From: [Victor Dodier](#)
To: [citycouncil](#)
Subject: January 11 Council agenda item 6.a concerning Rural-Hoyt Connection
Date: Sunday, January 10, 2021 3:49:13 PM
Attachments: [VJD comments on Dec 14 staff report.docx](#)

Subject: City staff report of December 14 concerning a potential connection between Candalaria and Fairmount neighborhoods.

PROJECT ESTIMATE SKETCH:
RURAL AV SE AND HOYT ST SE
PEDESTRIAN PATH
OPTION 5 (PIONEER CEMETERY PATH)

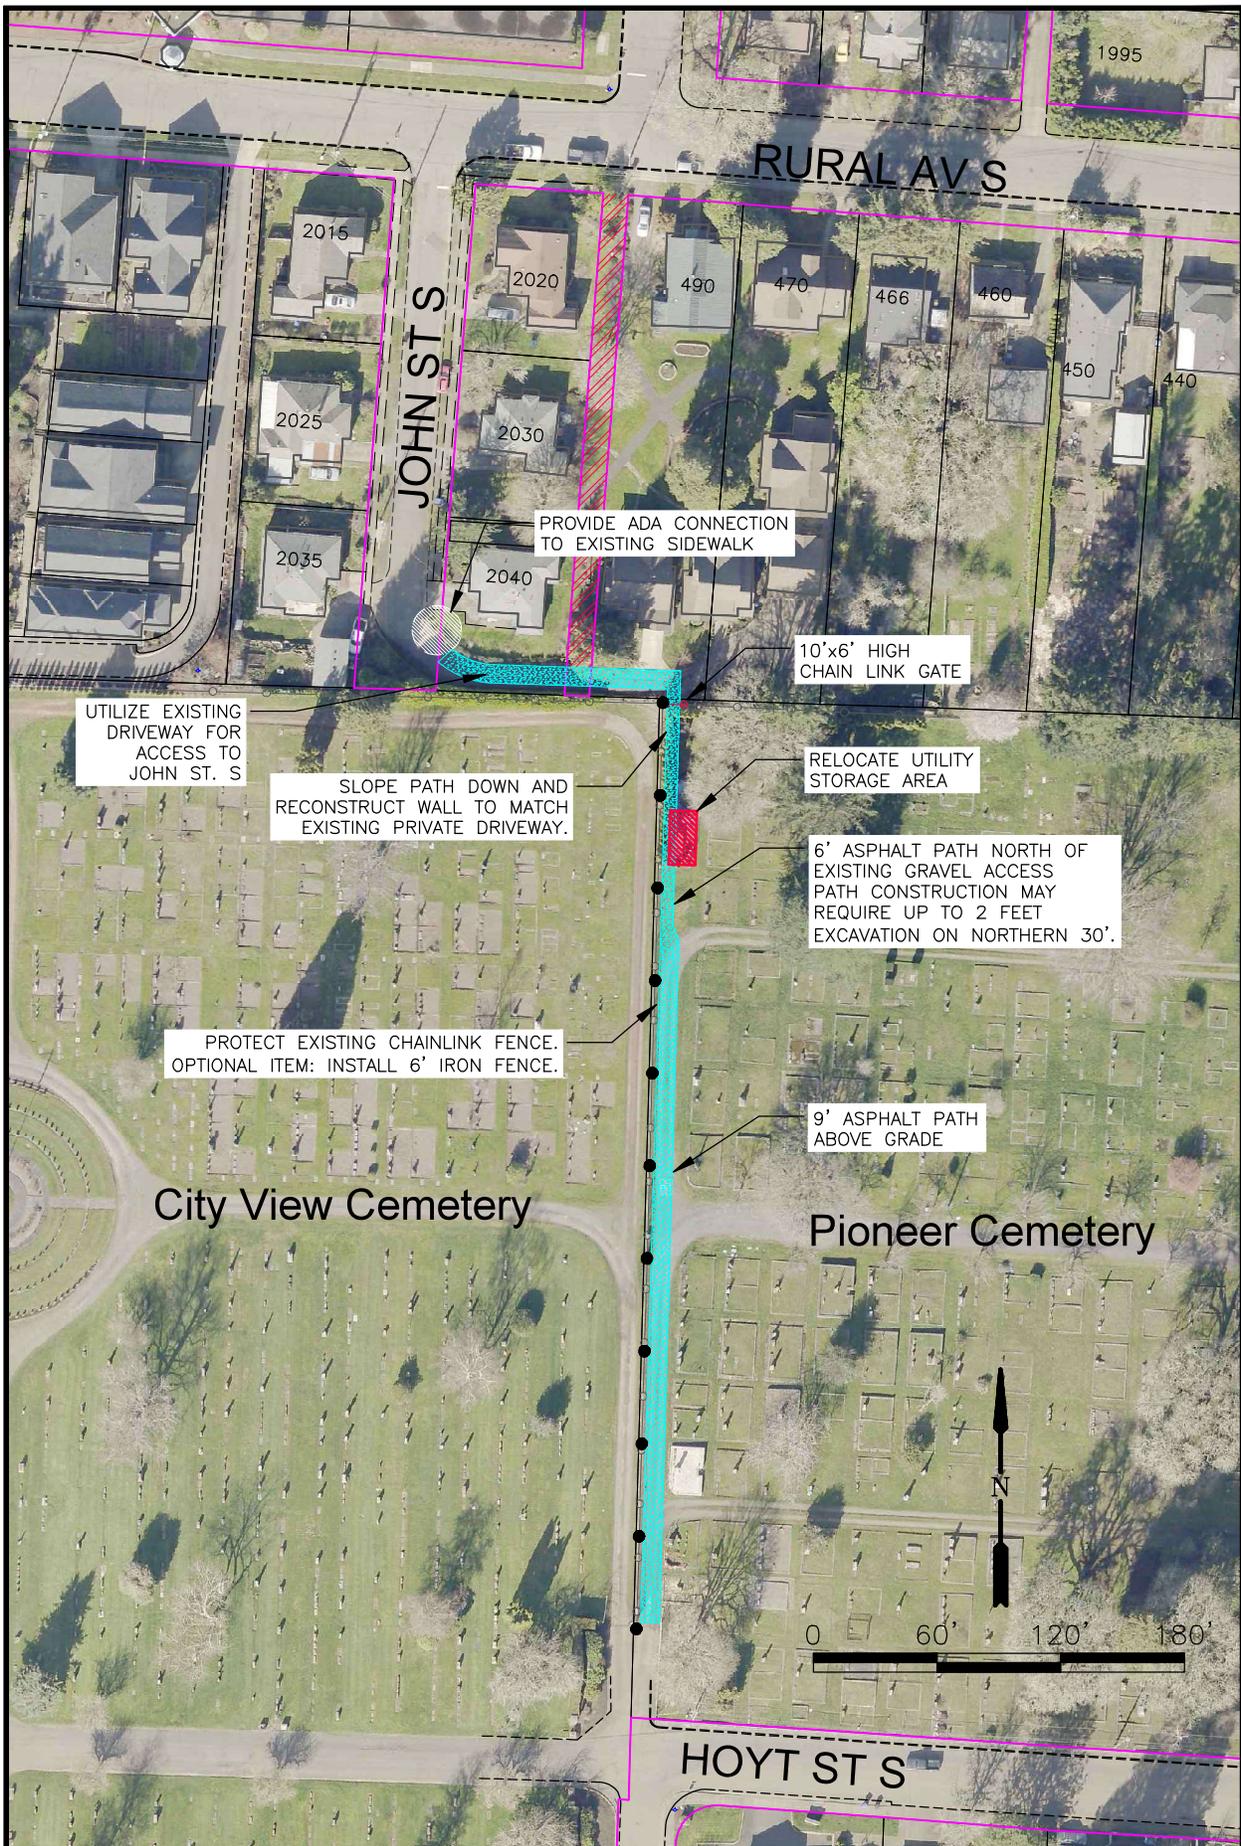
You will see, by the attached map, my home is one of the most affected by this proposal. Either if the sidewalk is extended to wrap around my yard or if the path is cut immediately behind my home – into my yard and next to my bed and bathroom windows.

You will see, by the attached map, my home is one of the most affected by this proposal. Either if the sidewalk is extended to wrap around my yard or if the path is cut immediately behind my home – into my yard and next to my bed and bathroom windows.

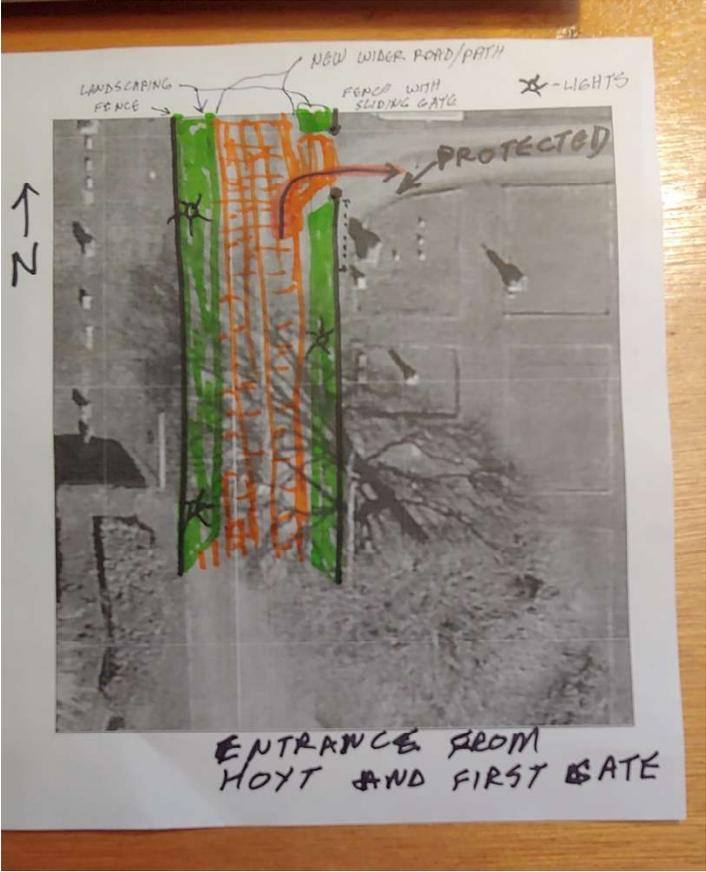
The picture below is a very rough depiction of the same area showing the new landscaping, one road/path instead of two, the new location for the security fences, new lighting, and a gate location that prevents vehicles from cutting across gravesites.

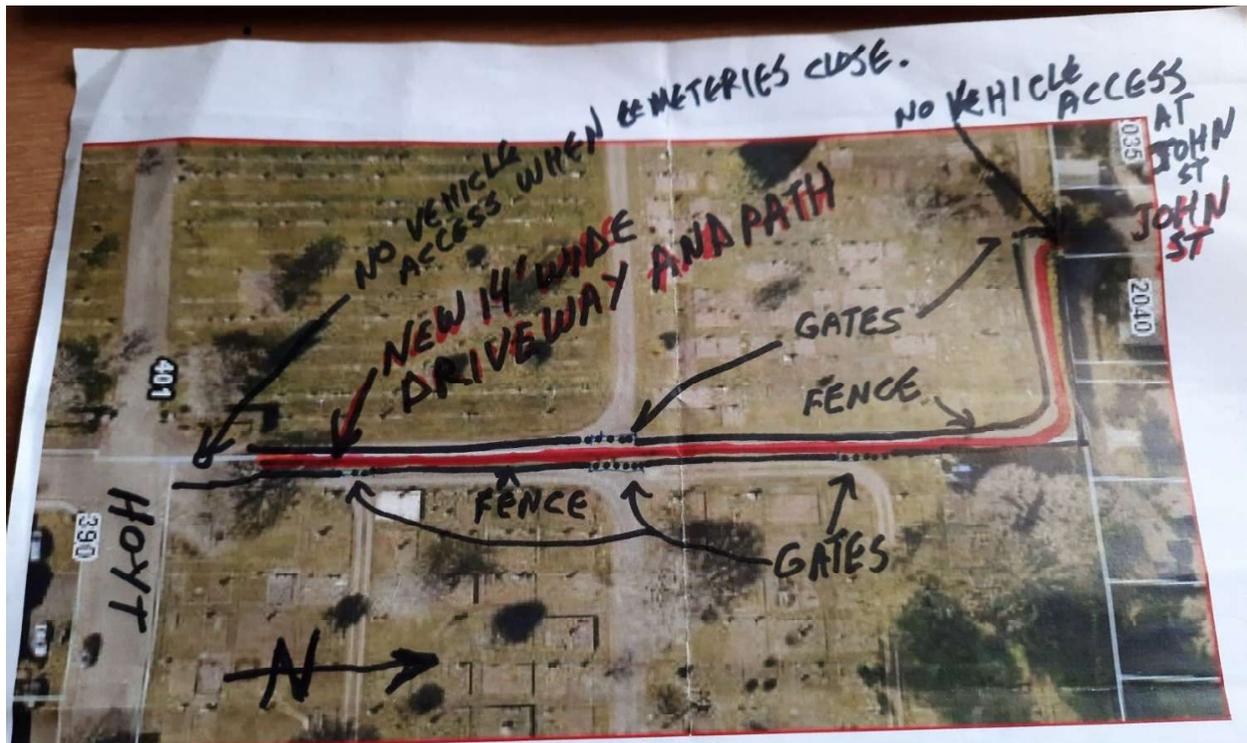
The picture below shows where John Street ends at the cemetery. From the wall at the blue dashed line to the cemetery fence is 14 feet. The 2-ft high wall could be removed and regraded for a gradual path descent to John Street. Lighting would be enhance security in this now-dark cul-de-sac.

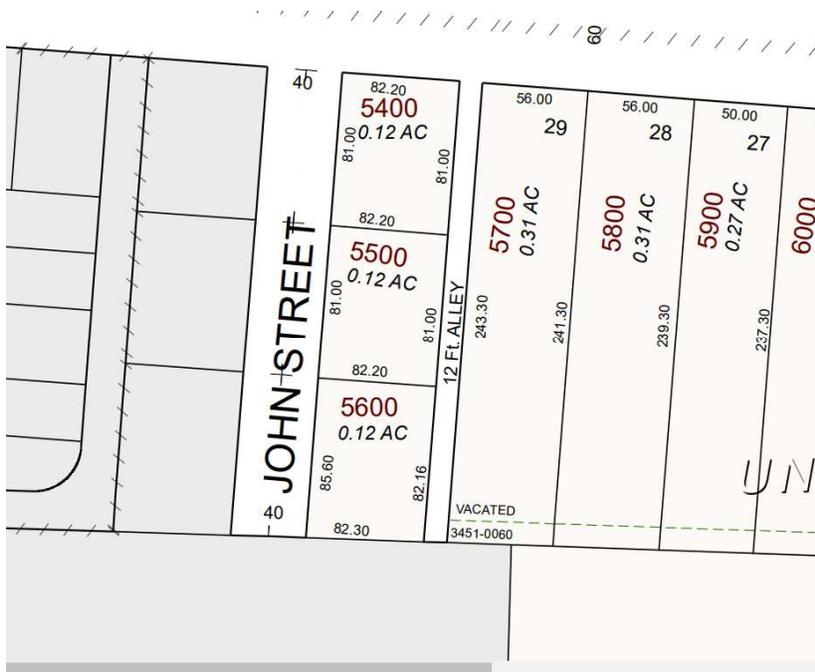
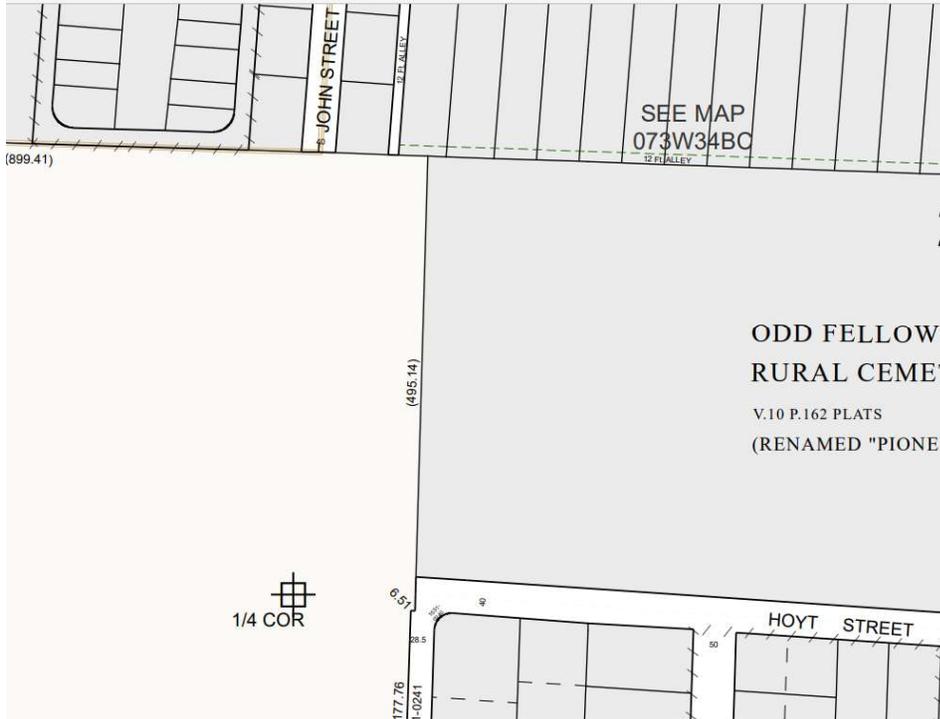
The very rough sketch below shows the access to the cemeteries for vehicles and the access to John Street for pedestrians and bicycles that would be open 24/7. The cemetery gates could be closed as needed by the cemeteries.
